**Program Bulletin**

# **CUSTOMER SATISFACTION PROGRAM**

# SUBJECT: Untreated Rivets and Poor Paint Finish on Underside of Hood

## MODELS: 2014 Buick Verano 2014 Chevrolet Sonic

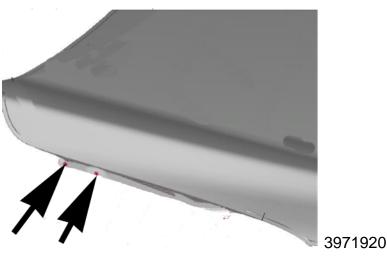
Note: **The Rivet Inspection** section of this procedure only applies to Sonic vehicles, for Verano vehicles, proceed directly to the **Finish Repair and Corrosion Protection** steps.
